RED LINE REVISION NO. 1
October 11, 2011
INSTALL SEPERATE CONDUIT FOR INTERCONNECT CROSSING MD 543
TEDD Approval:

MD 7 AND MD 543 (RIVERSIDE PKWY/CRESWELL RD)
BELCAMP, MARYLAND

TRAFFIC SIGNALIZATION PLAN

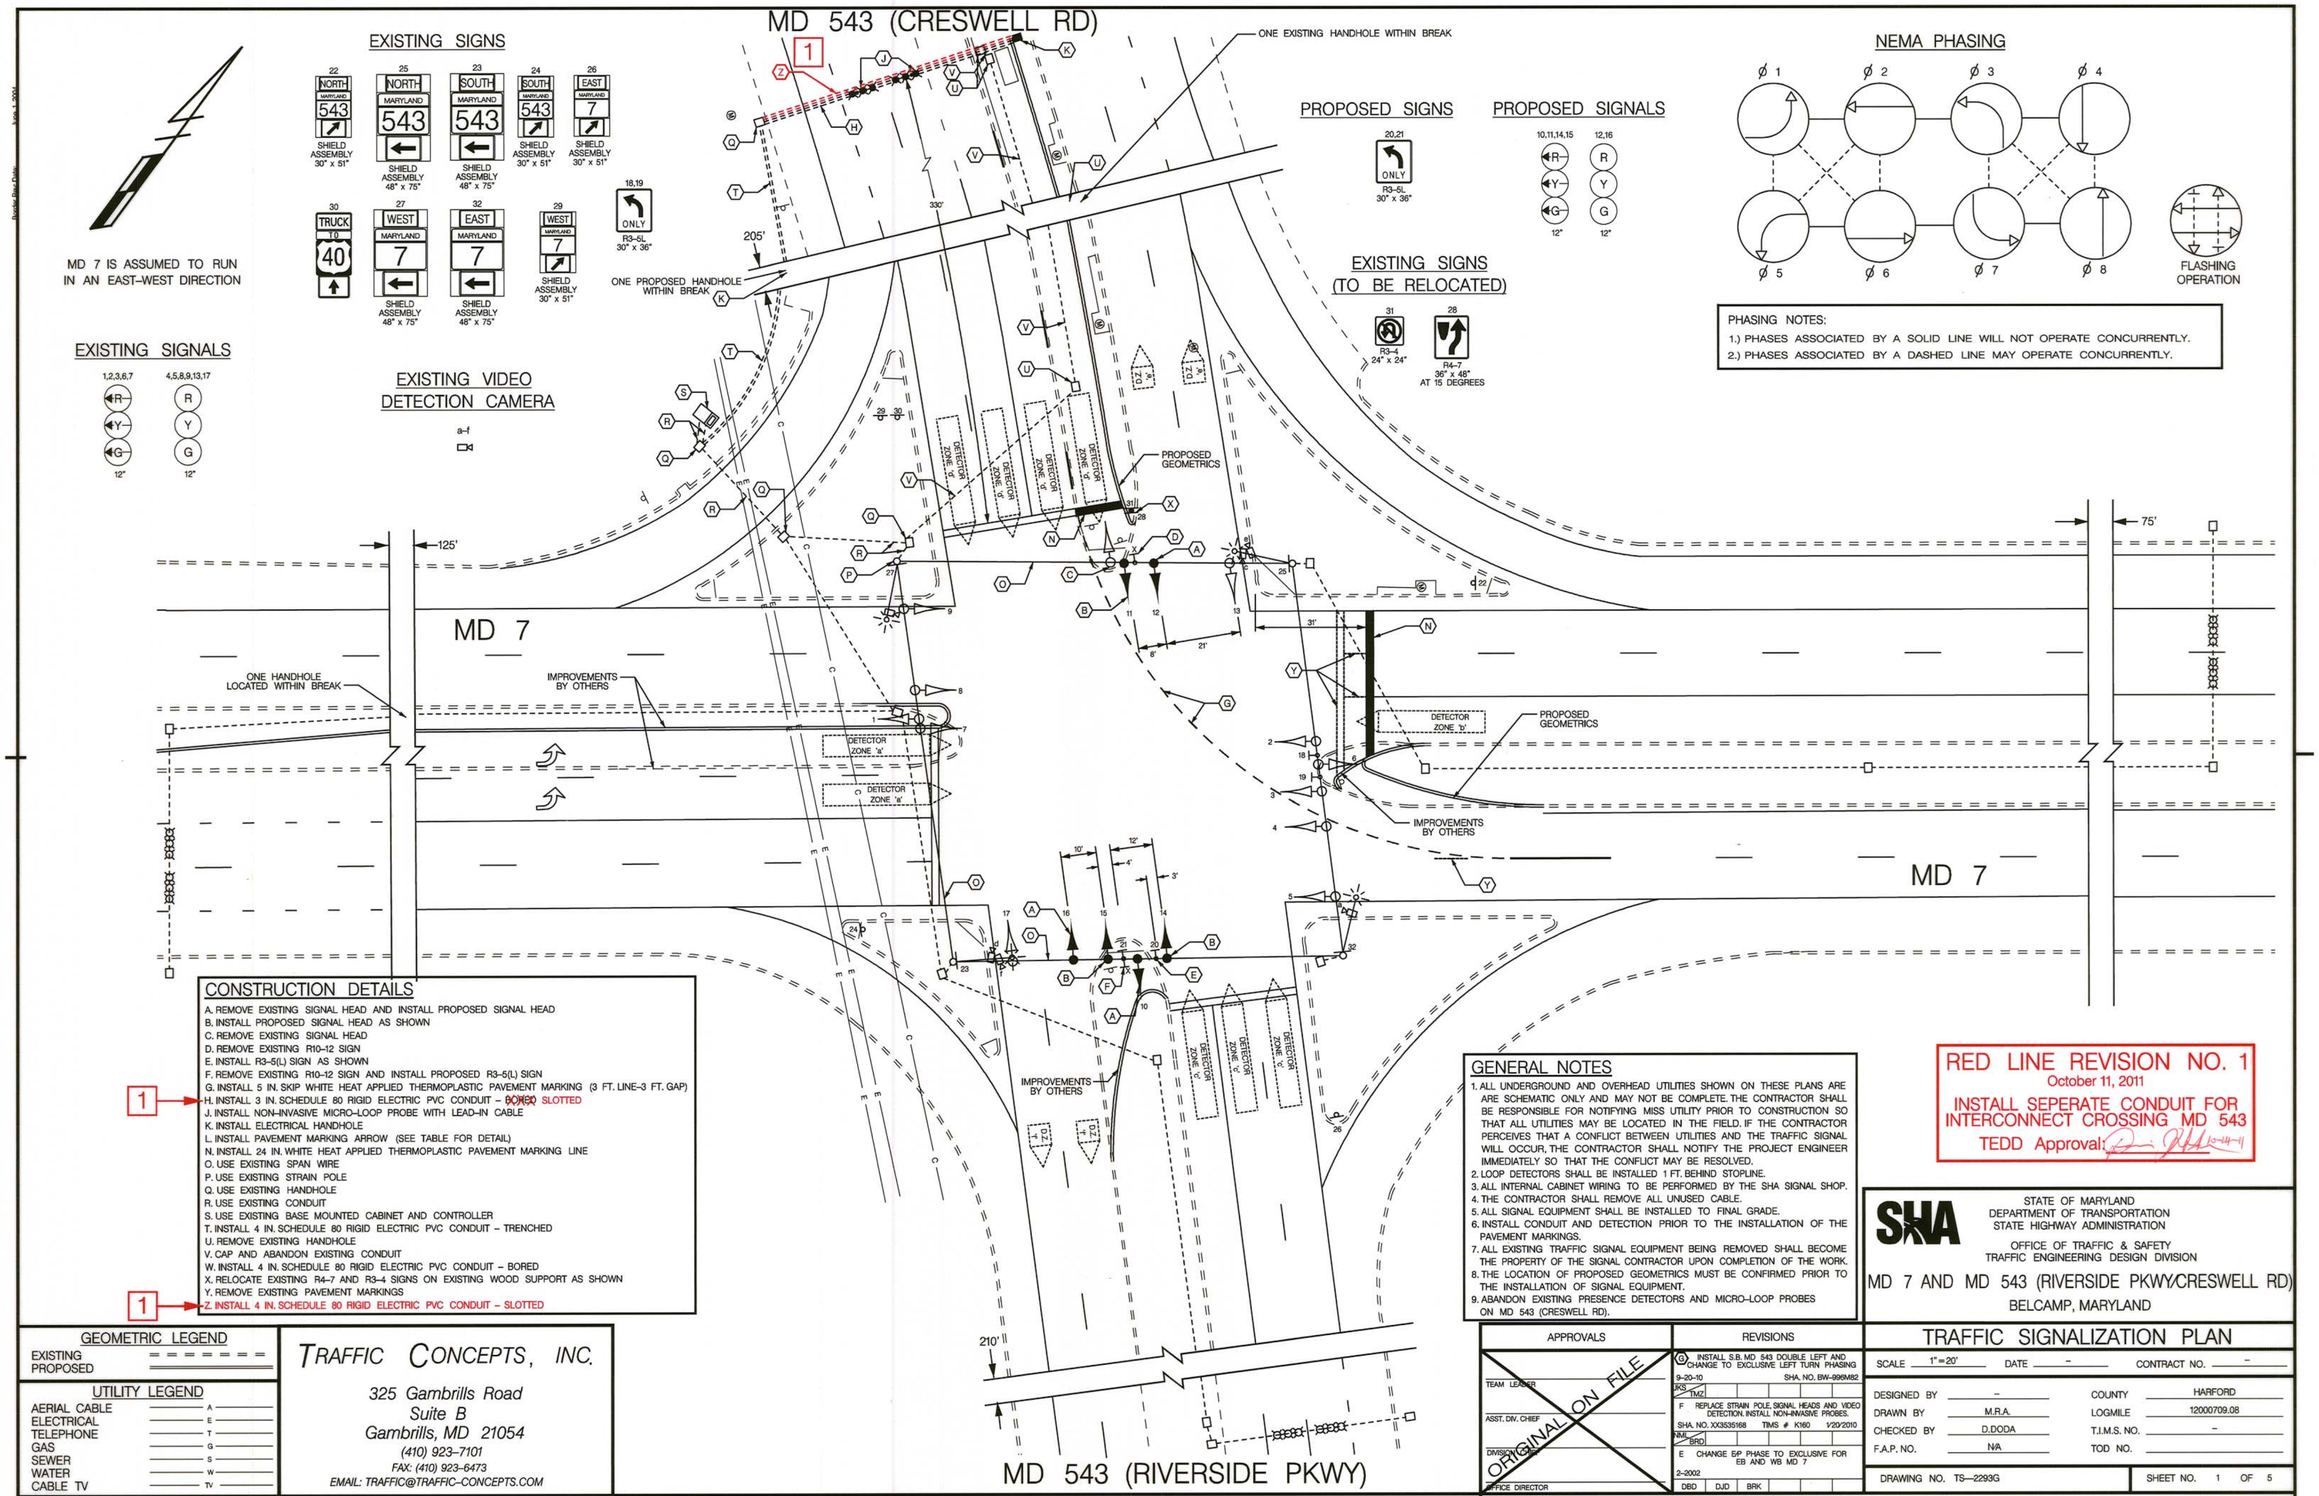
E. INSTALL R3-5(L) SIGN AS SHOWN
F. REMOVE EXISTING R10-12 SIGN AND INSTALL PROPOSED R3-5(L) SIGN
G. INSTALL 5 IN. SKIP WHITE HEAT APPLIED THERMOPLASTIC PAVEMENT MARKING (3 FT. LINE-3 FT. GAP)
1 H. INSTALL 3 IN. SCHEDULE 80 RIGID ELECTRIC PVC CONDUIT – ~~BORED~~ SLOTTED
